PF225 Change Request

106

O-1, O-2 & O-3

Remove projects O-1 through O-3 from the PF225 Baseline.

First Approach

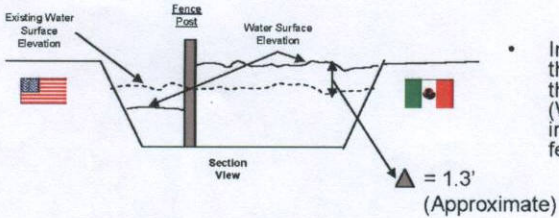
- Current analysis assumes a reasonable but relatively high lateral flow rate. This resulted in relatively low change in (WSE) and minimum impact on Mexican side of fence.

Second Approach

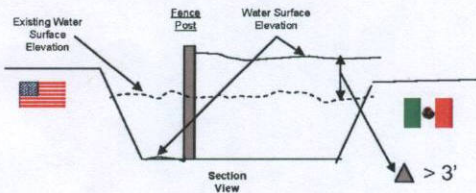
- Independent check recommended changing the lateral flow modeling approach to reduce the lateral flow rates which will increase the (WSE) on south side of the fence and further increase the impacts on Mexican side of fence.
